King Street Pump Station Improvements (Volume I) & ASR Lime System Improvements (Volume II) - RFCSP
Solicitation Number: CO-00670
Job No.: 20-6002 and 22-8603

ADDENDUM 2
October 12, 2023

D-202

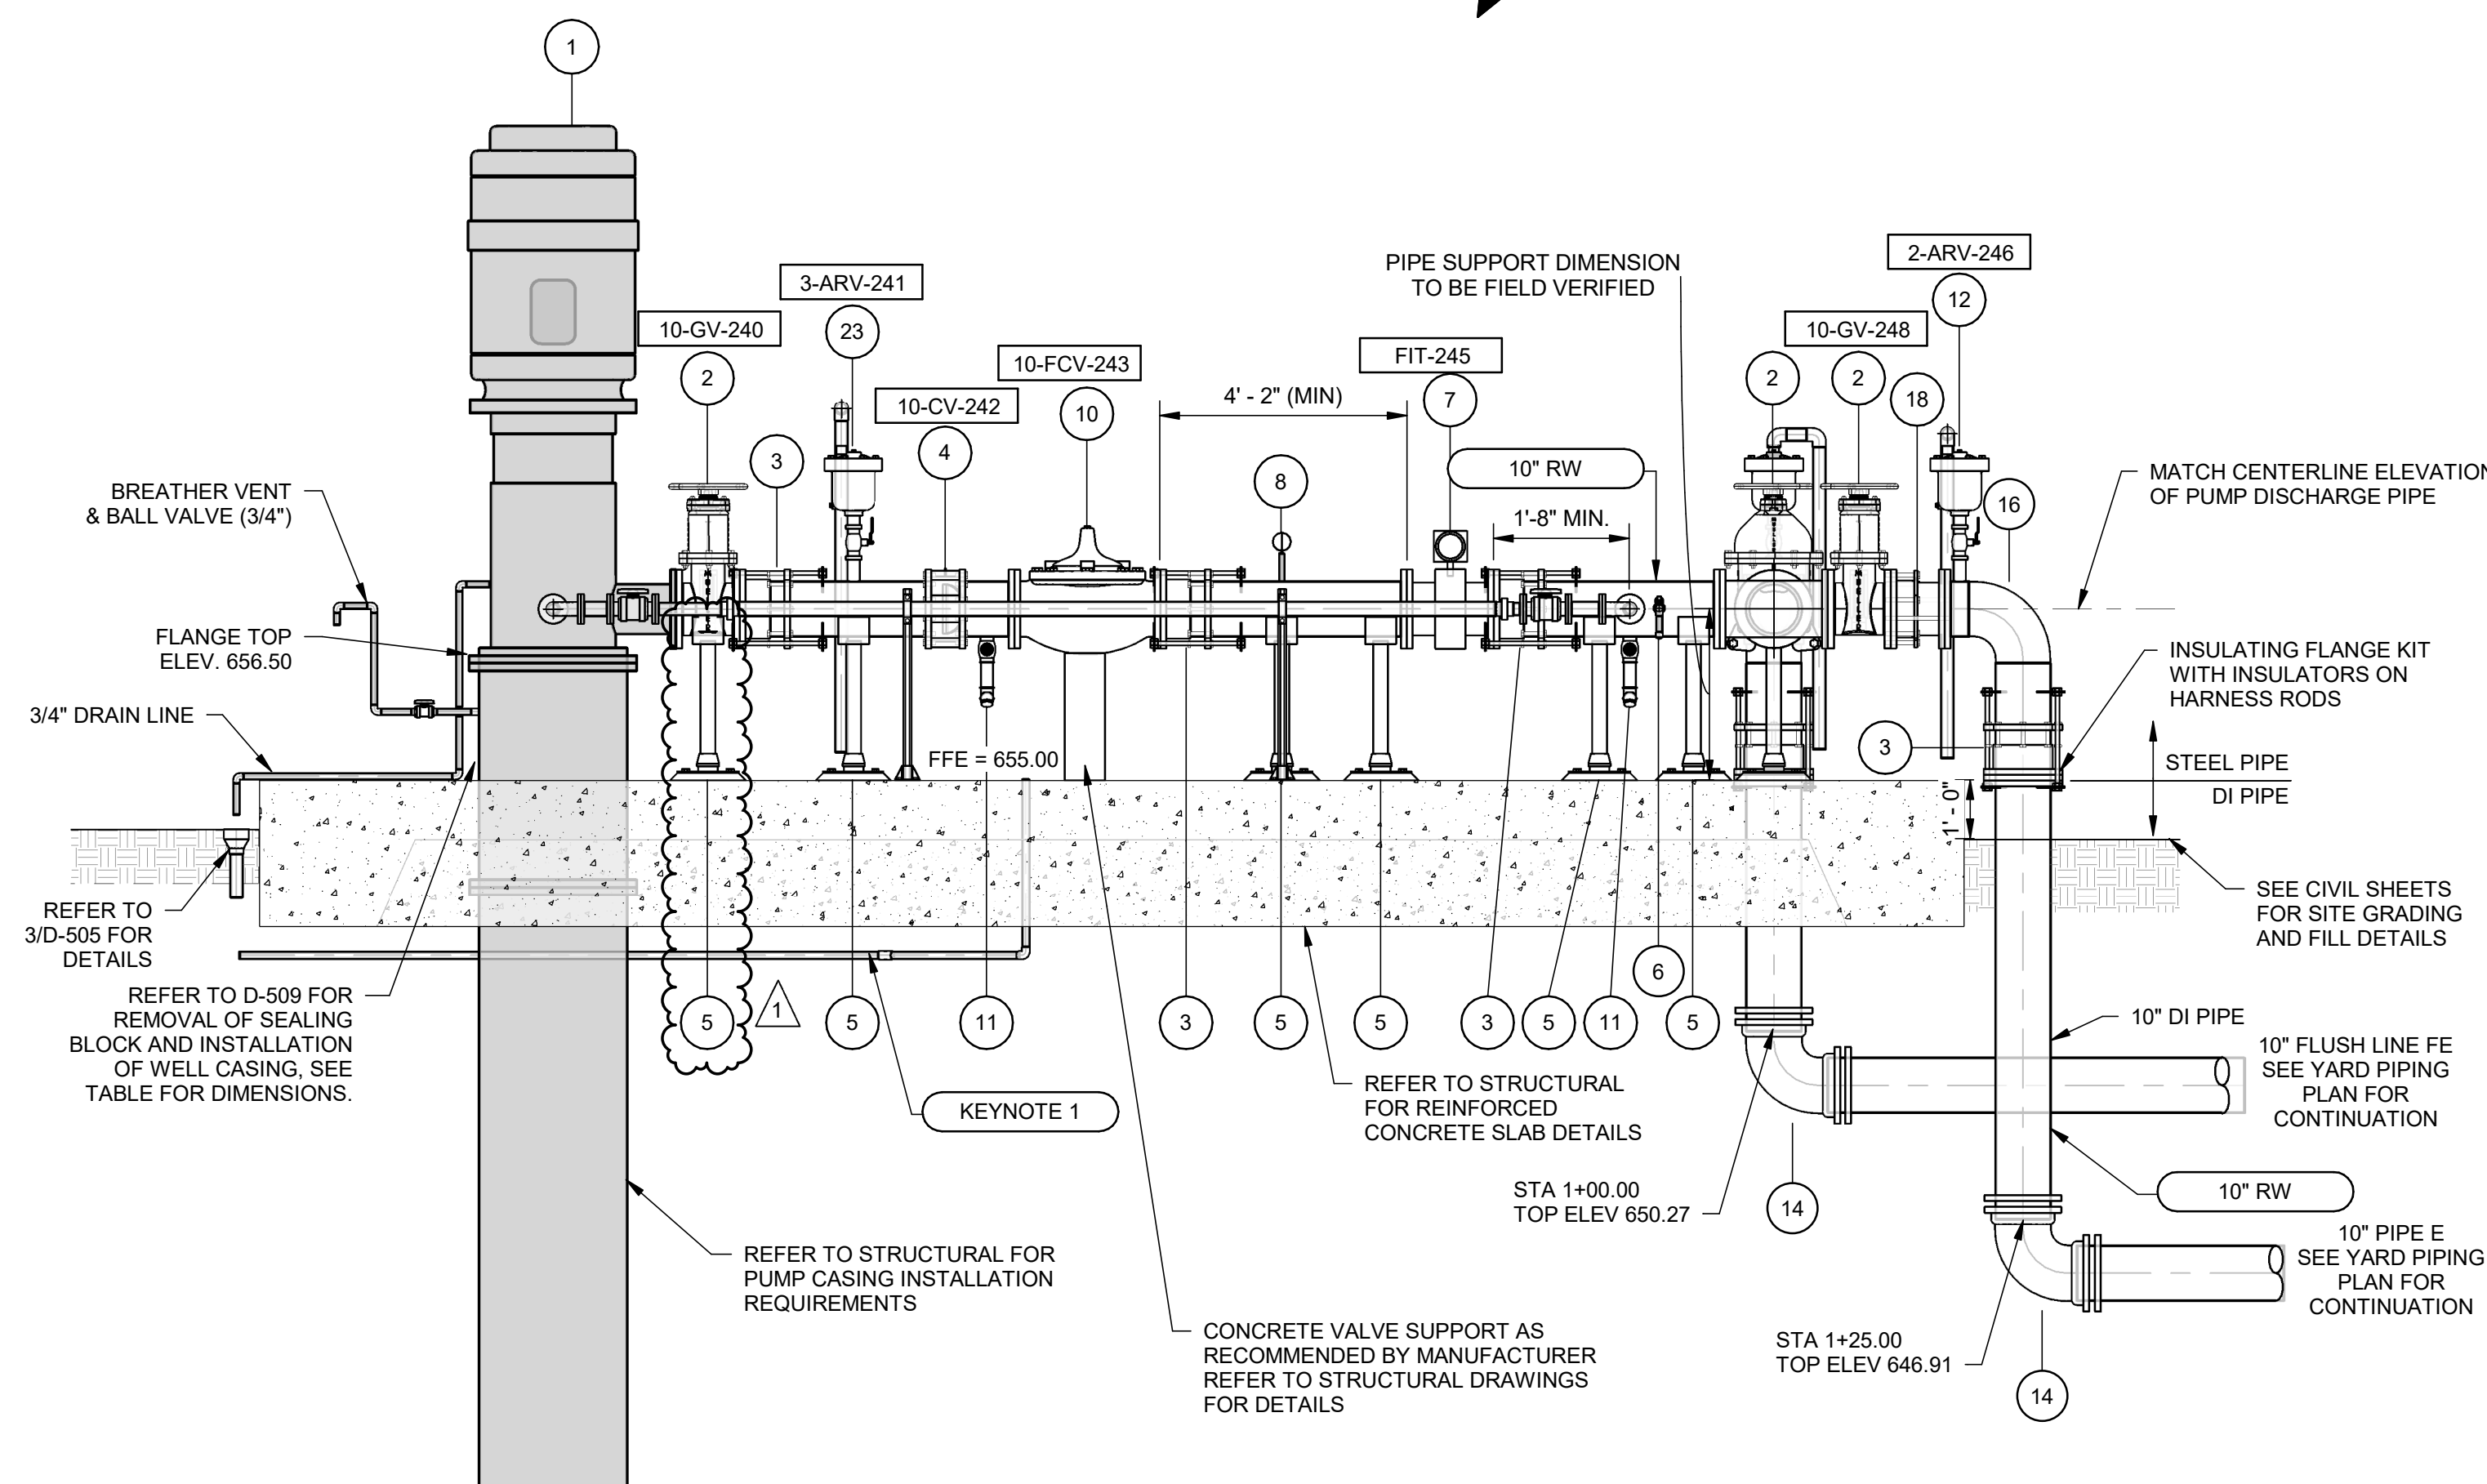
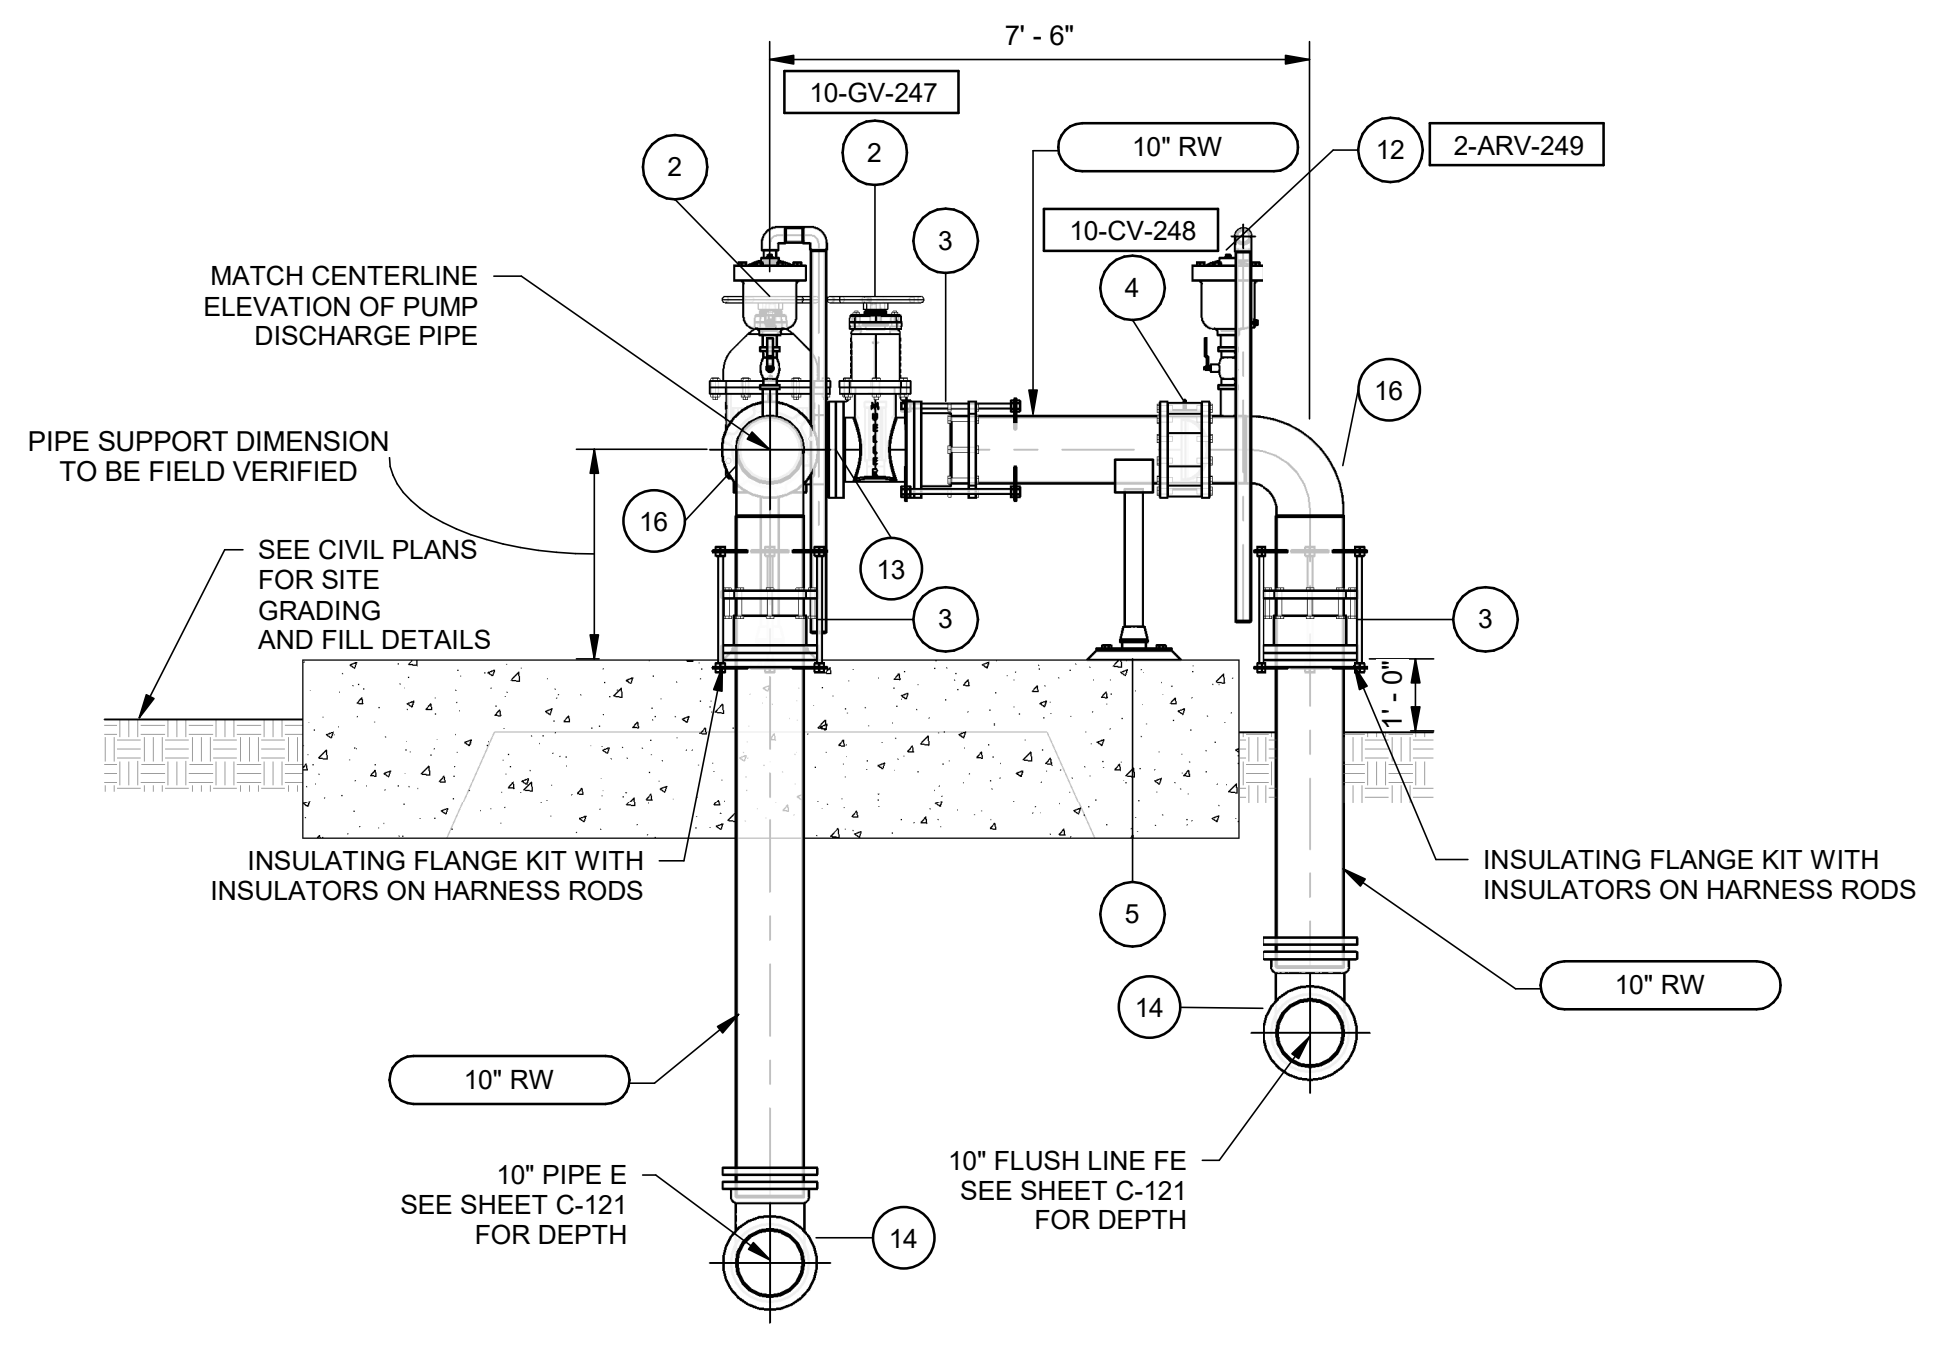
- 49. Question: Contract Drawings, Sheet D-203/204, add permanent pipe support under 12" gate valve that completely supports weight. Pump discharge should not be anchor point for any of discharge piping.**

Response: Refer to "Changes to the Plans" section item No. 3, item No. 4, item No. 5, and item No. 6 in this addendum. Pipe support added to drawings.
- 50. Question: Contract Drawings, Sheet D-203/204, add housekeeping pad/foundation around well casing pipe extended above finish floor. Surface plate assembly will be welded to well casing after installation/leveling. Grout to be poured up to bottom surface of top plate of the surface plate assembly.**
